Addendum No. 2

Fotteral Square RFP (2400 N. 11th Street)

Philadelphia Redevelopment Authority

**Fotteral Square
Bidder Questions and Answers**

REVISIONS

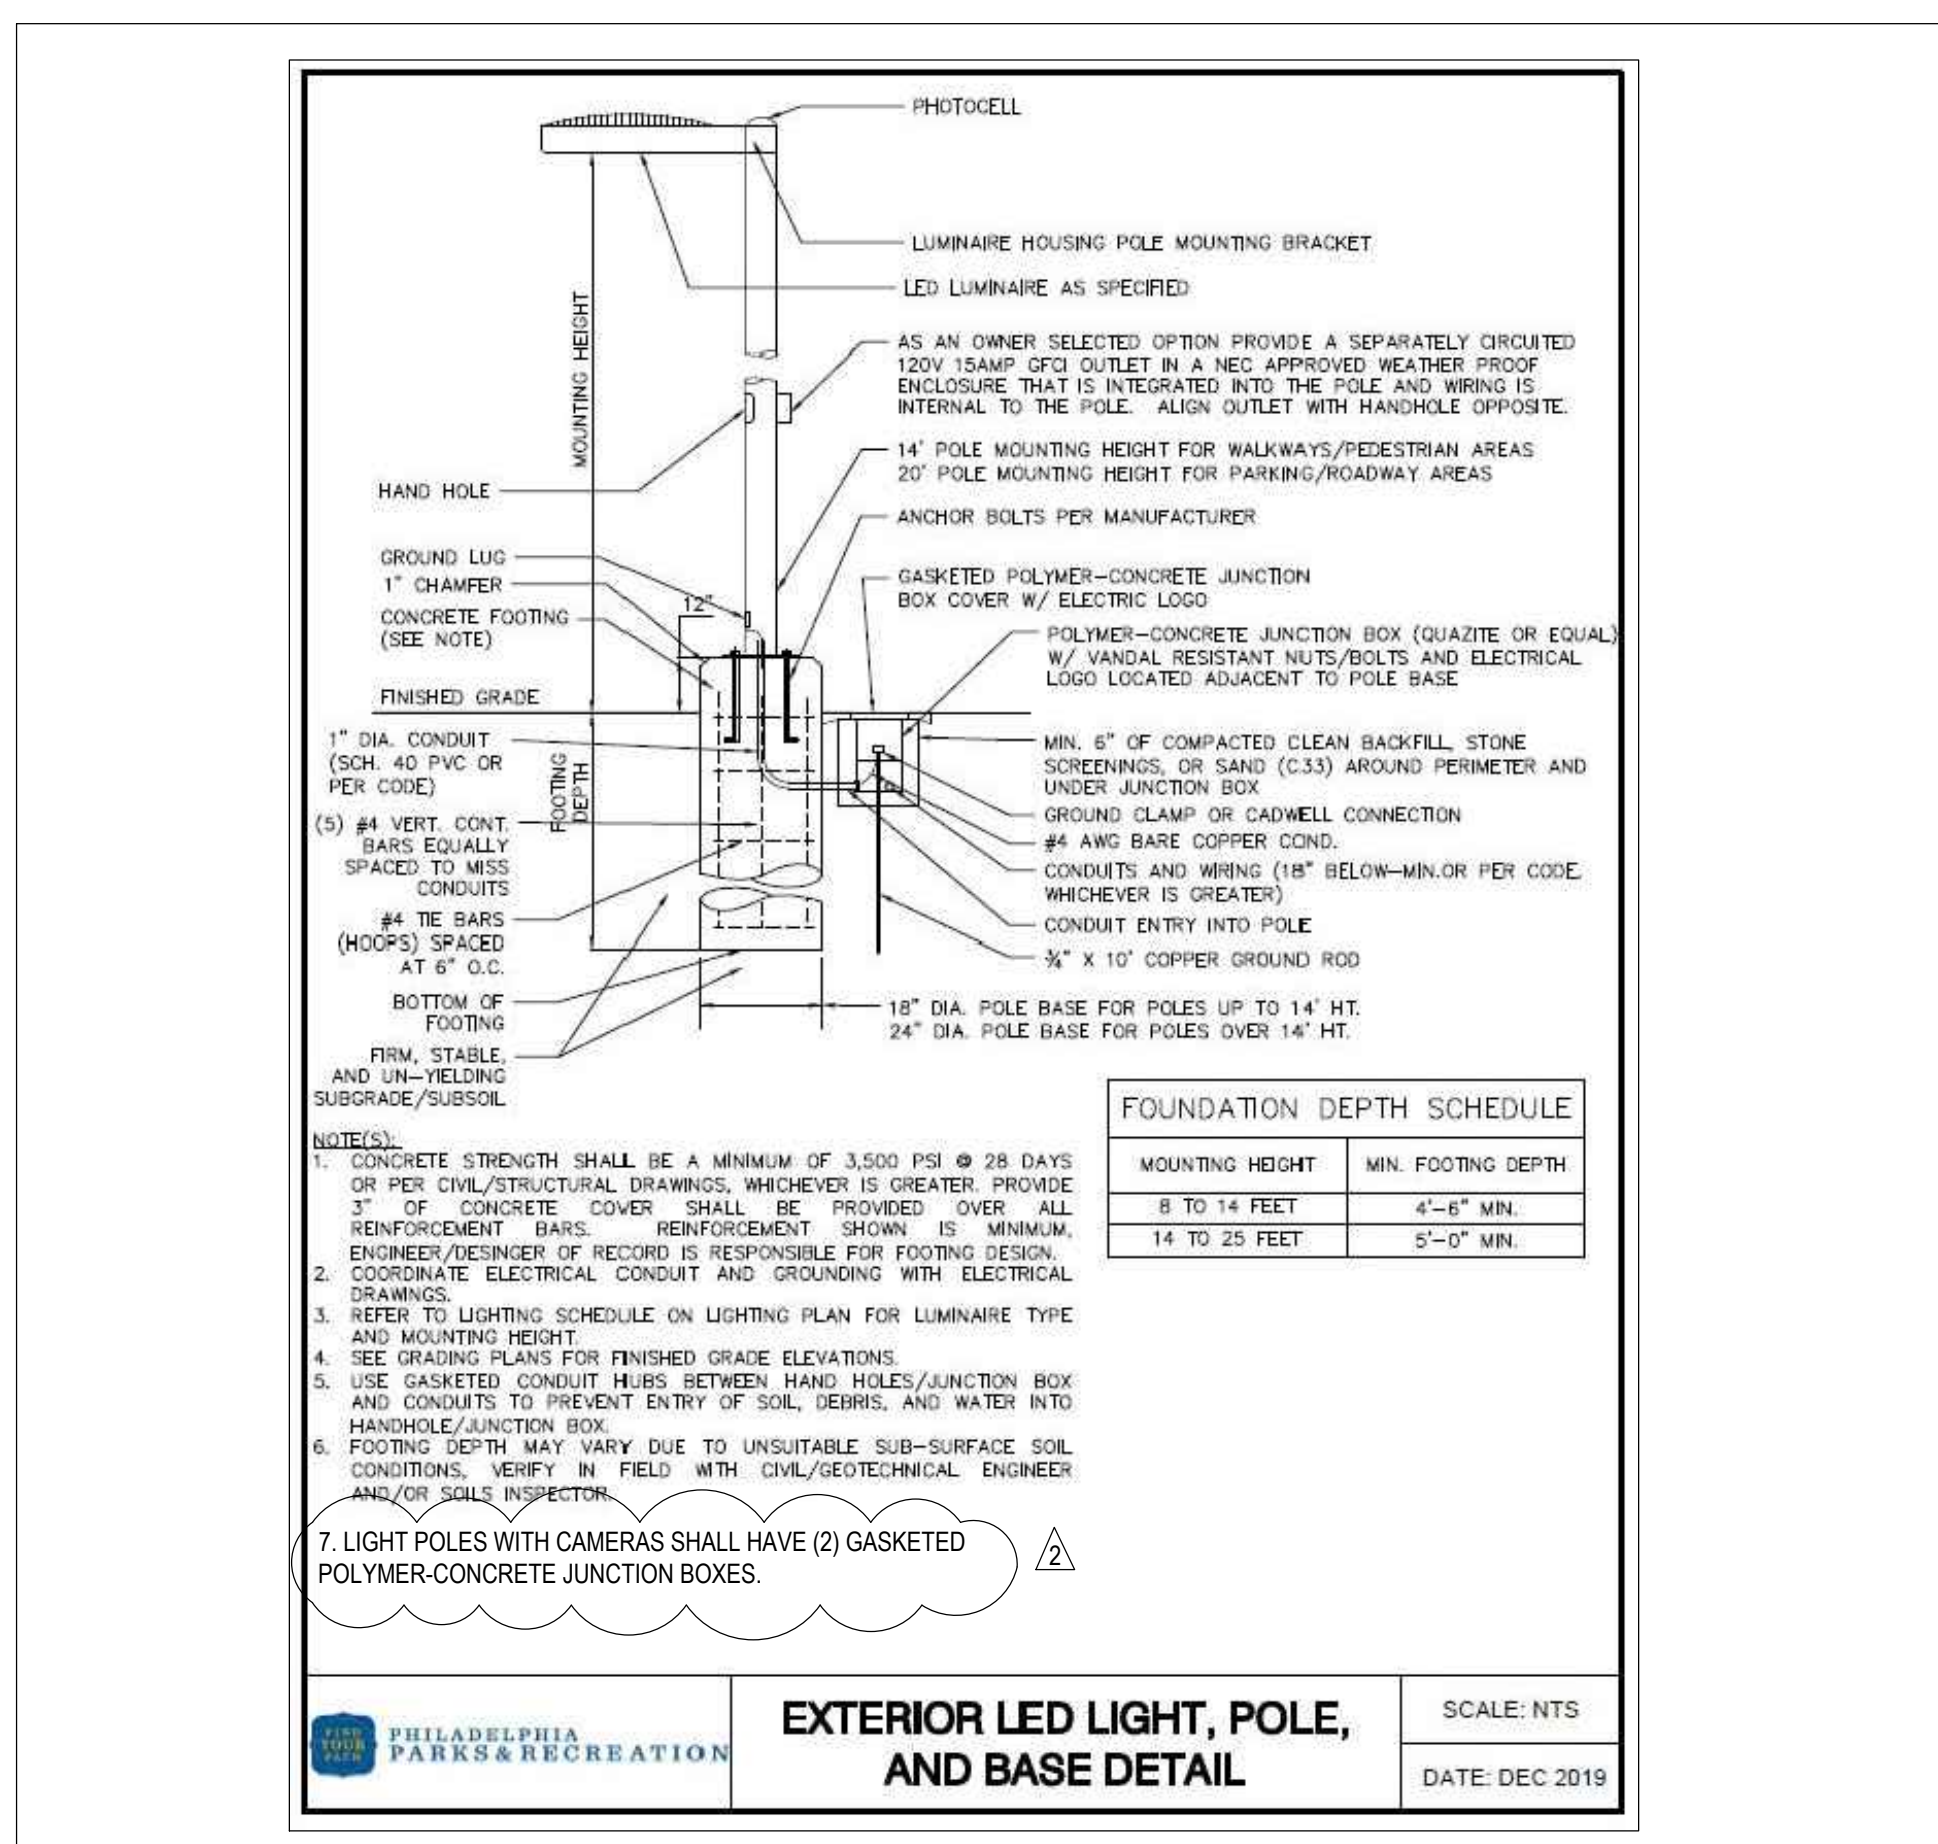
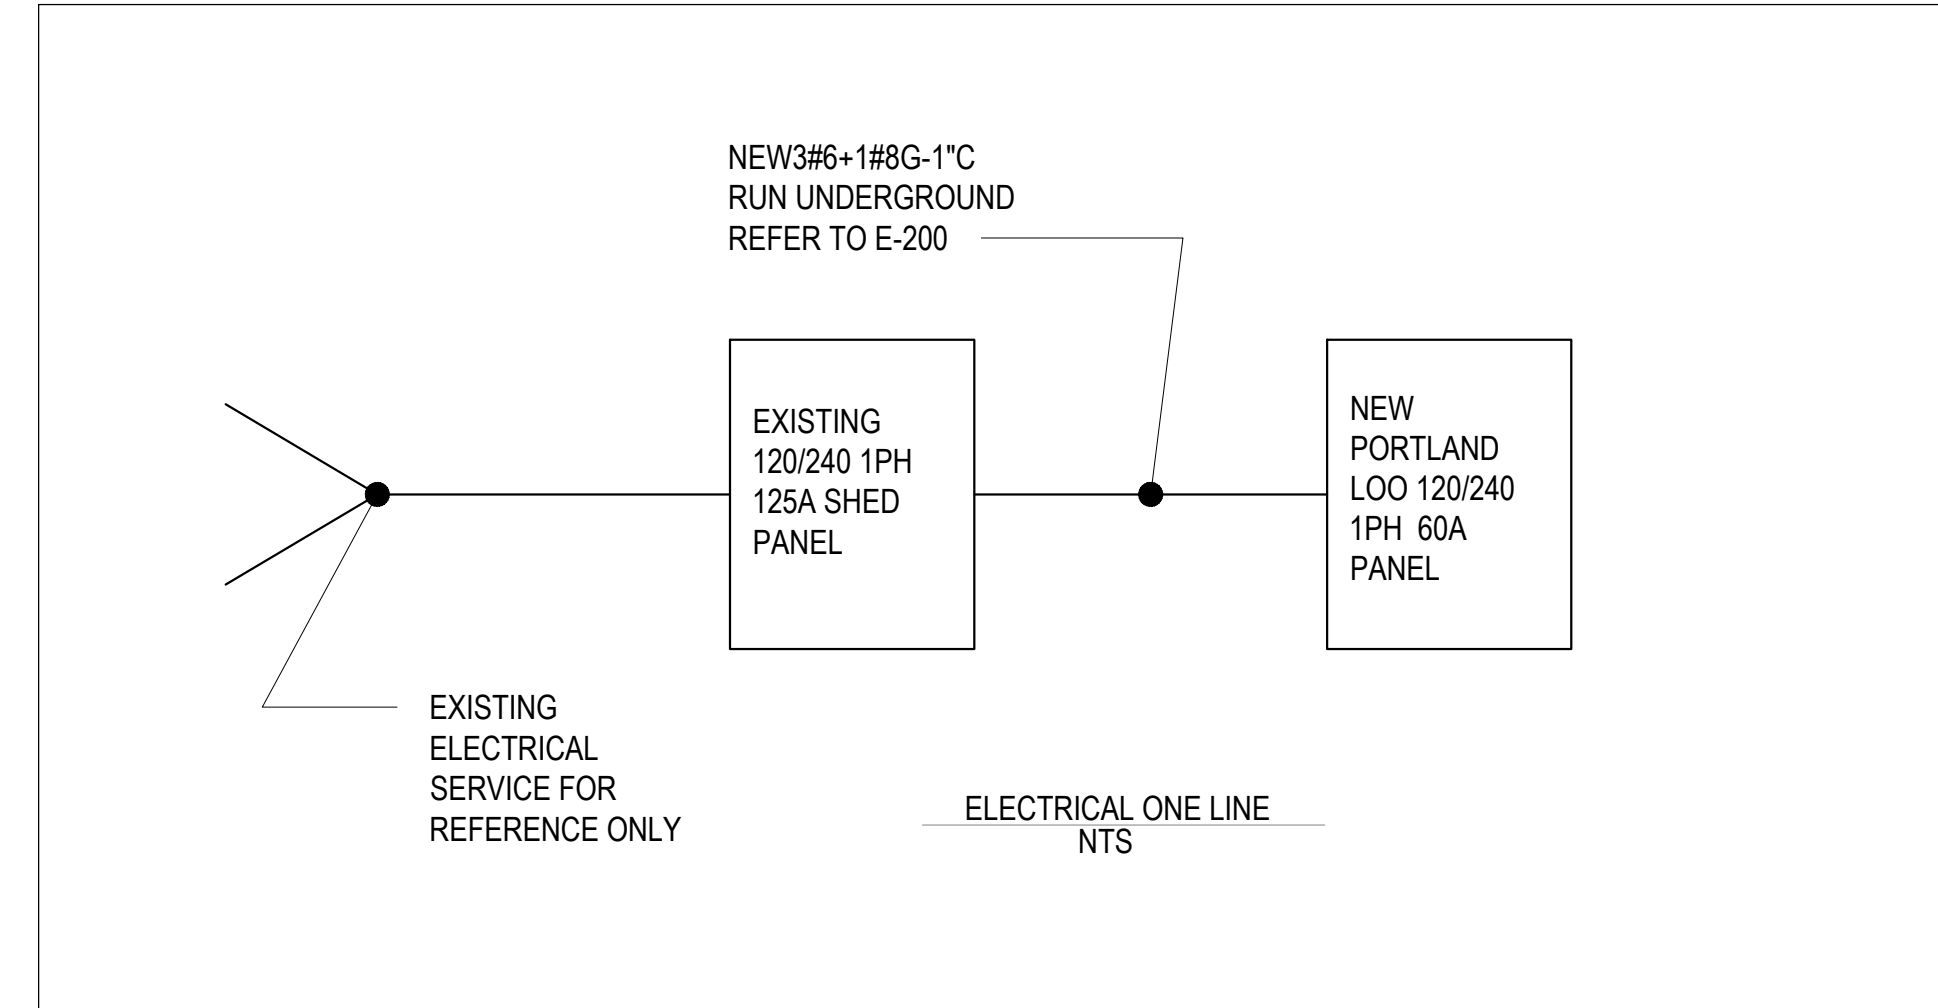
7. Drawing E-001 General Note #30: Please confirm "all underground conduit will be galvanized rigid steel" instead of PVC which is the Recreation Dept. norm. This will add over 20% to the electrical quote in manhours and material.

8. Drawing E-001-Pole and Base Detail: Are two Polymer-Concrete junction boxes required at each pole, one for power and one for cameras? Pole diameter is too small to loop conduits in and out.

Response: Rigid PVC conduit shall be used for all underground raceways in areas not regularly subject to vehicular traffic, for raceways in concrete walls, floors, and ceilings, and for raceways to be run through cinder fill. Provide a separate, code-sized ground wire in each PVC conduit.

Response: A single junction box may be used at each pole if it complies with all codes.

30. ALL UNDERGROUND CONDUIT SHALL BE HOT DIPPED GALVANIZED STEEL WITH WARNING TAPE ABOVE IT. RIGID PVC CONDUIT IS ACCEPTABLE TO USE FOR ALL UNDERGROUND RACEWAYS IN AREAS NOT REGULARLY SUBJECT TO VEHICULAR TRAFFIC. PROVIDE CODE-SIZED GROUND WIRE IN EACH PVC CONDUIT AS PER NEC 250.

PROJECT NO. 2020-513	DRAWING NO. E-200
DATE 07/20/2022	
SCALE AS NOTED	
DRAWN BY MS	
CHECKED BY JB

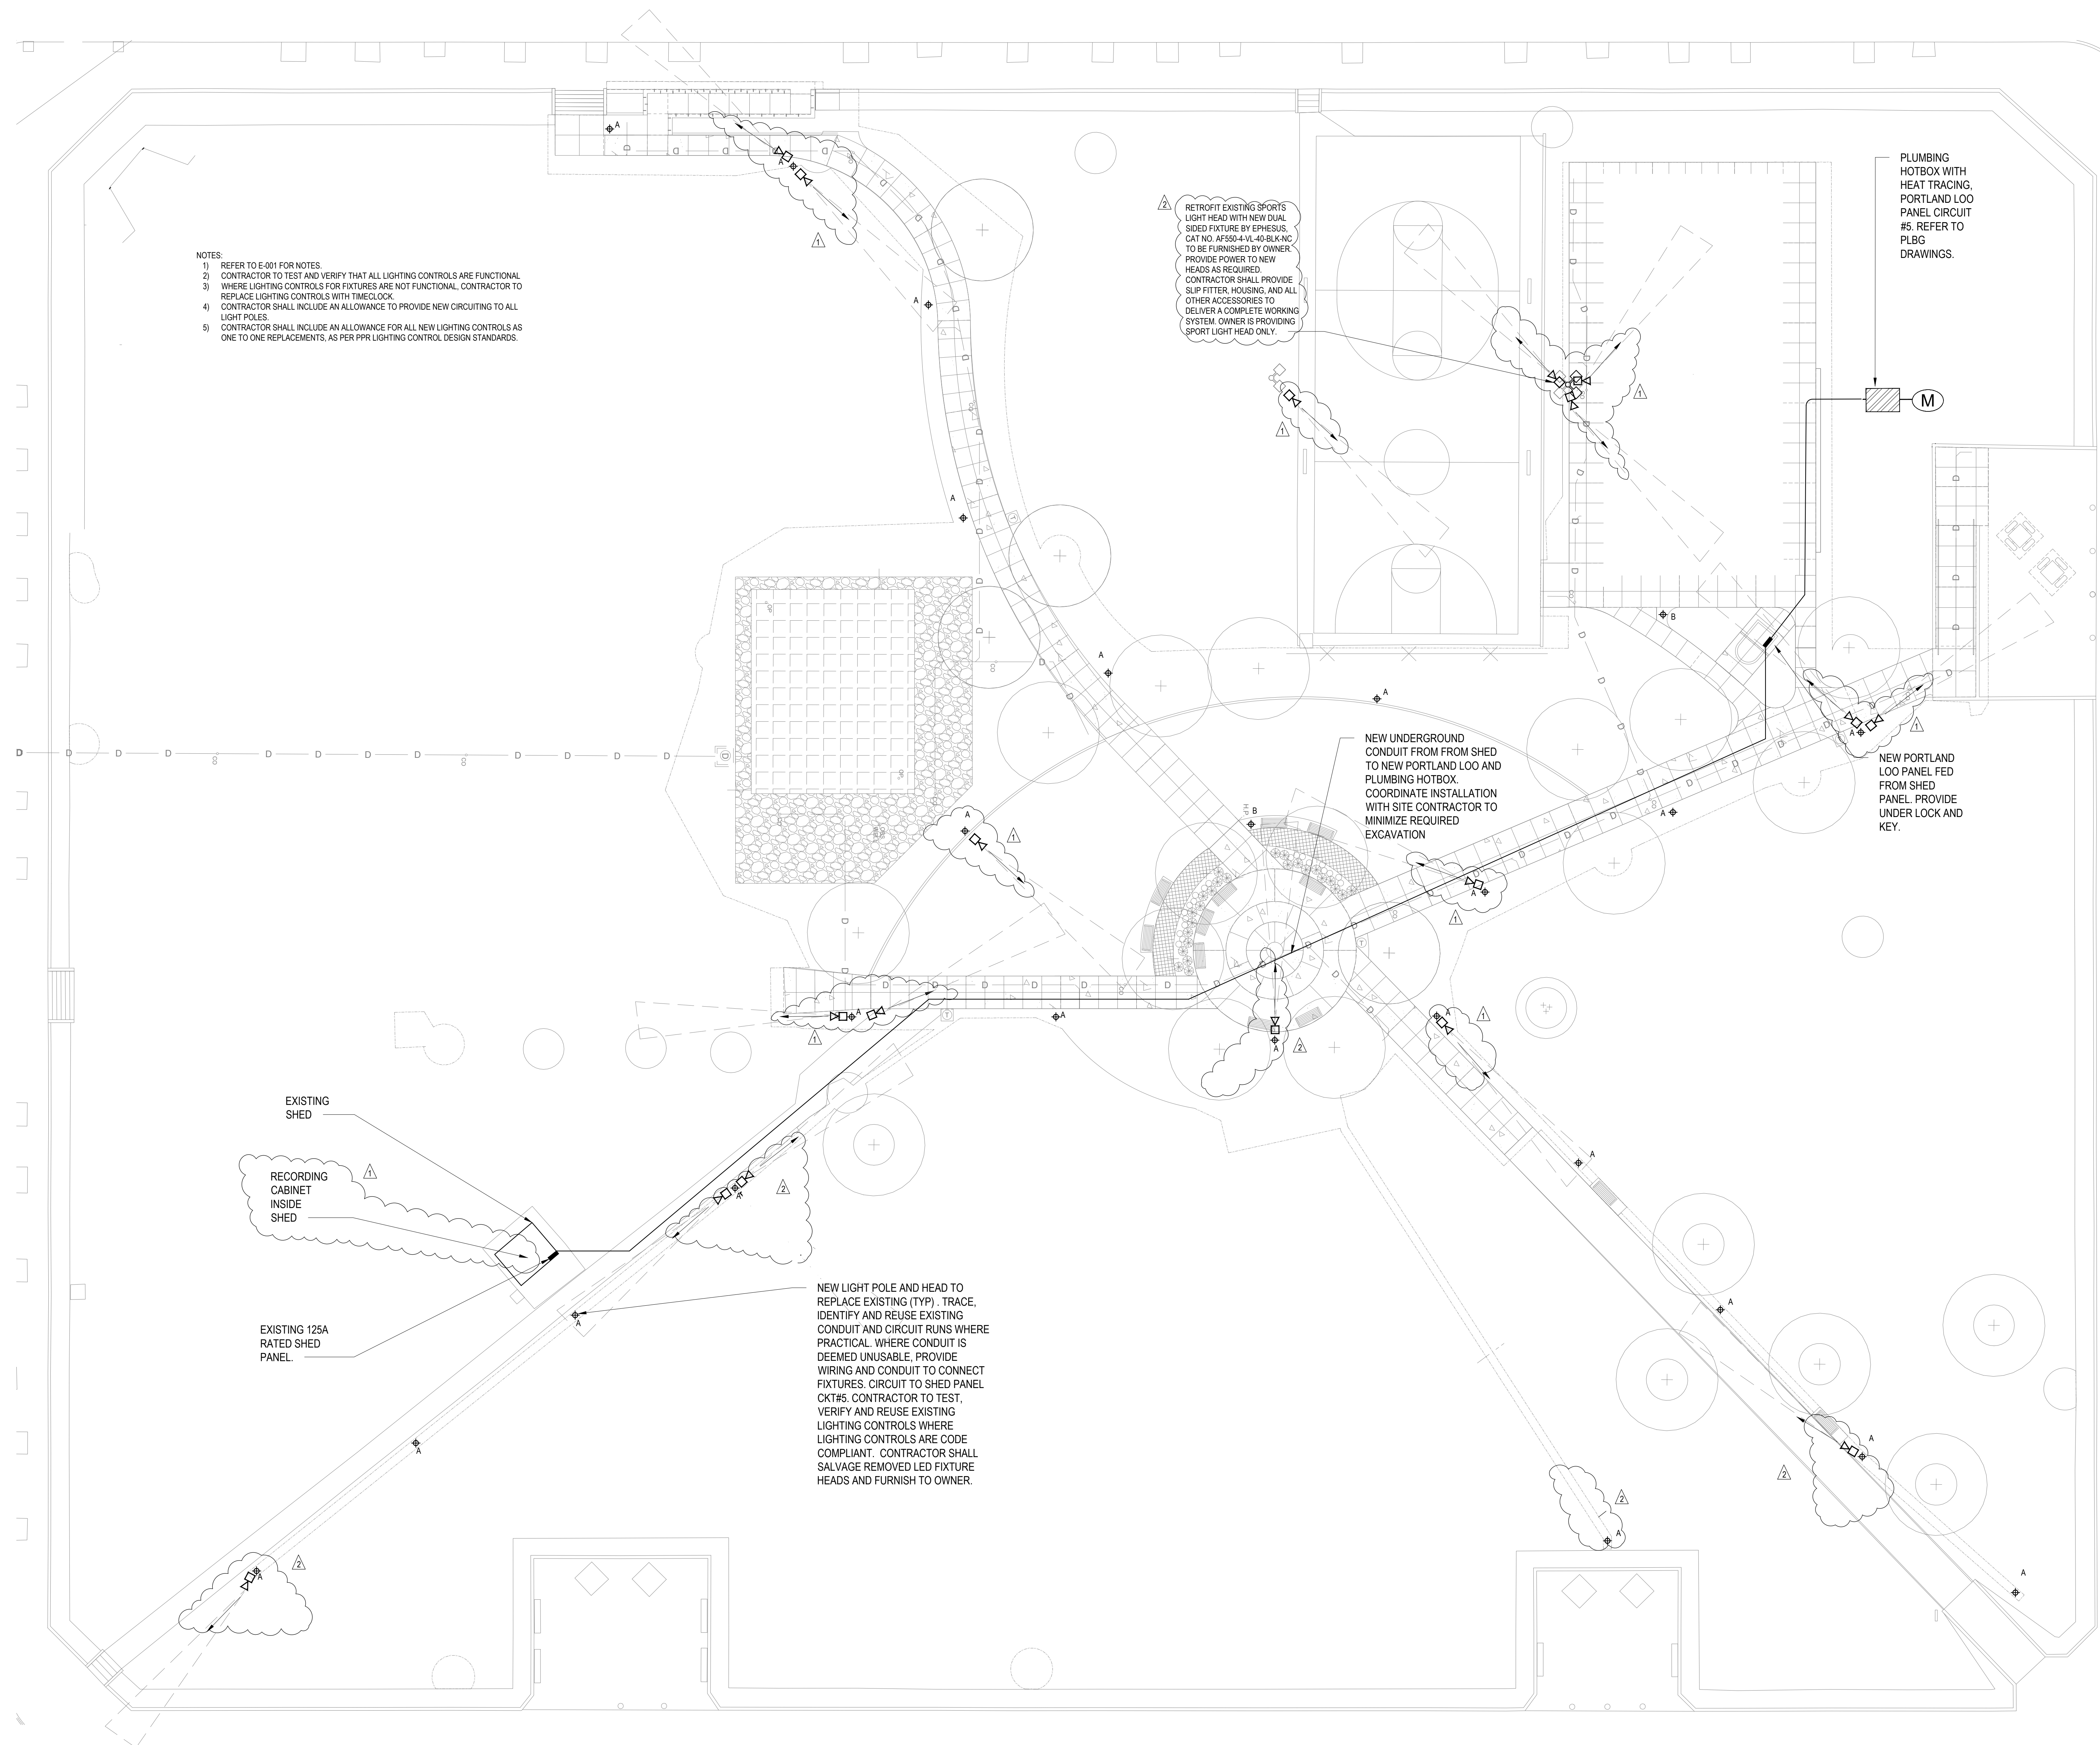
11. Drawing E-200-Owner furnished pole lights: Will lights be furnished with all accessories (2" slip fitter) for contractor to install?

13. Note on drawing E-200 "New light pole and head to replace existing (TYPICAL). Trace, identify and reuse existing conduit and circuit runs where practical. Where conduit is deemed unusable, provide wiring and conduit to connect . The existing wiring to poles is direct burial aluminum wire fed off the street from PECO. The new pole is 3 ½" and will not fit on existing bases. We also need camera wiring at 23 of the 25 poles which isn't addressed. How do you get conduit and wiring into an existing concrete pole base?

Response: Two new lights will be added to the existing pole to face the mini-pitch. The City will provide two light heads (cutsheet attached). The Contractor must provide all mounting hardware and accessories as necessary for a complete installation.

Response: Contractors to assume installation of all new pole bases, conduit, power wiring and camera wiring.
